Questions from November 19, 2009 CAC Meeting
Willamette River Bridge Vertical Clearance and Bike Connections

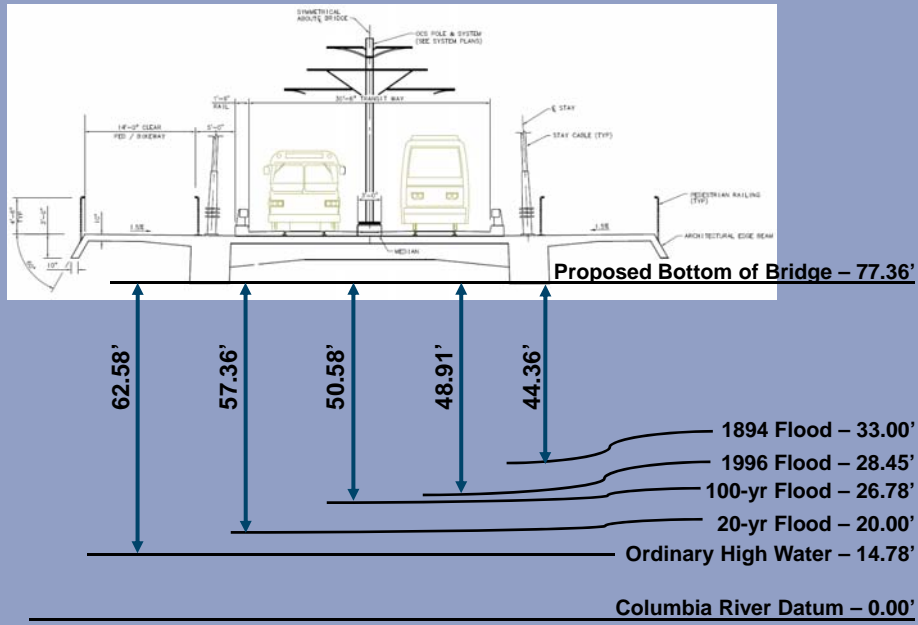
17) Analysis of other vessels affected?

The project team hired a consultant to produce a river user study for the Portland-Milwaukie project. Between her work and the work of the project team, a comprehensive list of vessels using this stretch of the Willamette River and their height was compiled and the project team contacted everyone who might not have 100 percent passage under the Willamette River Bridge with the vertical clearance of 75' (the vertical clearance being evaluated at that time). All vessel owners were satisfied with the proposed Willamette River Bridge matching the current vertical clearance of the Sellwood Bridge (75') except for Portland Spirit and Gray's Harbor Historic Seaport Authority. Portland Spirit has requested 85' vertical clearance. The project team continues to work with Portland Spirit and their concerns. Gray's Harbor has requested 90' vertical clearance for their two tall mast sailing vessels when they participate in the Rose Festival activities. The project received a letter from the Rose Festival Association stating that the community value of the Willamette River Bridge outweighs the needs of one of their vendors needing that stretch of the river one time each year and that they would be willing to work with Gray's Harbor to find another way for them to continue to participate in the Rose Festival. (See attached summary slides for the proposed clearances below the Willamette River Bridge at various river stages.)
